Updated comment #111 D2.2:

Subject: Equation 33A-4:

33.3.8.10 PD pair-to-pair current unbalance

Figure 33-37— I_{Con-2P} and $I_{Con-2P-unb}$ evaluation model

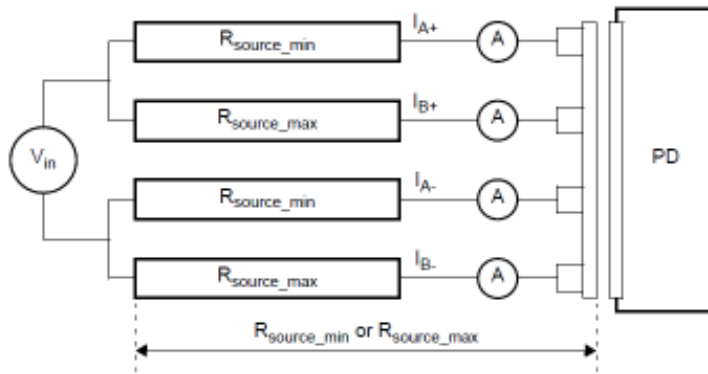
Under all operating states, single-signature PDs assigned to Class 5 or higher shall not exceed $I_{\text{Con-2P-unb}}$ for longer than $TCUT-2P_{\text{min}}$ as defined in Table 33–18 on any pair when PD PI pairs of the same polarity are connected to all possible common source voltages in the range of $V_{\text{Port_PSE-2P}}$ through two common mode resistances, $R_{\text{source_min}}$ and $R_{\text{source_max}}$, where $R_{\text{source_max}} = 1.186 * R_{\text{source_min}}$, and $R_{\text{source_min}}$ are all possible resistances in the range of 0.168Ω to 5.28Ω as shown in Figure 33–37.

Under all operating states, dual-signature PDs shall not exceed $I_{\text{Con-2P}}$ as defined in Equation (33–8) for longer than $TCUT-2P_{\text{min}}$ as defined in Table 33–18 on any pair when PD PI pairs of the same polarity are connected to all possible common source voltage in the range of $V_{\text{Port_PSE-2P}}$ through two common mode resistances, $R_{\text{source_min}}$ and $R_{\text{source_max}}$, where $R_{\text{source_max}} = 1.186 * R_{\text{source_min}}$, and $R_{\text{source_min}}$ are all possible resistances in the range of 0.168Ω to 5.28Ω as shown in Figure 33–37.

$R_{\text{source_min}}$ and $R_{\text{source_max}}$ represent the V_{in} source common mode effective resistance that consists of the PSE PI components ($R_{\text{PSE_min}}$ and $R_{\text{PSE_max}}$ as specified in 33.2.8.5.1, $V_{\text{Port_PSE_diff}}$ as specified in Table 33–18, the channel resistance, and influence of $R_{\text{Pair_PD_min}}$ and $R_{\text{Pair_PD_max}}$ ~~specified in Annex 33A.5~~ as function of system end-to-end unbalance). Common mode effective resistance is the resistance of two conductors of the same pair and their other components, which form R_{source} , connected in parallel including the effect of the total system pair to pair voltage difference. I_A and I_B are the pair currents of pairs with the same polarity.

Figure 33A-4—PD resistance unbalance elements overview

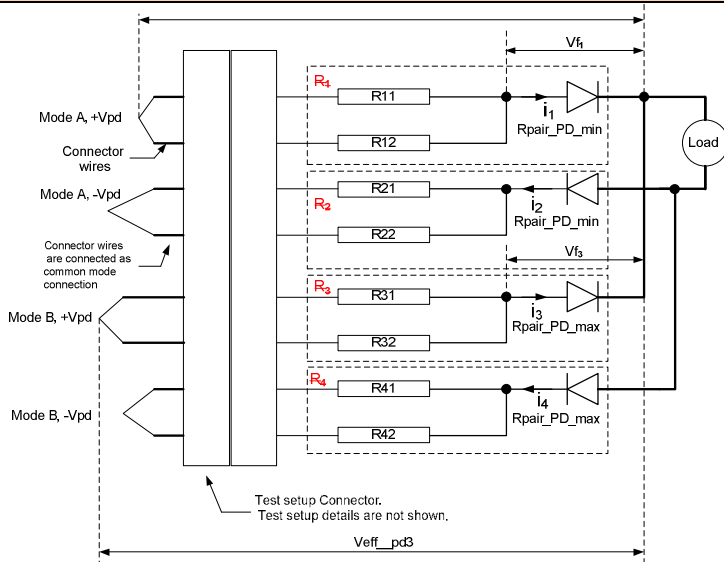
This is not part of the baseline
 We can simplify text and drawing by deleting R1, R2, R3 and R4 from the text and Figure 33A-4 since we have we have $R_{pair_PD_min}/max$ definitions already in the drawing and the text.
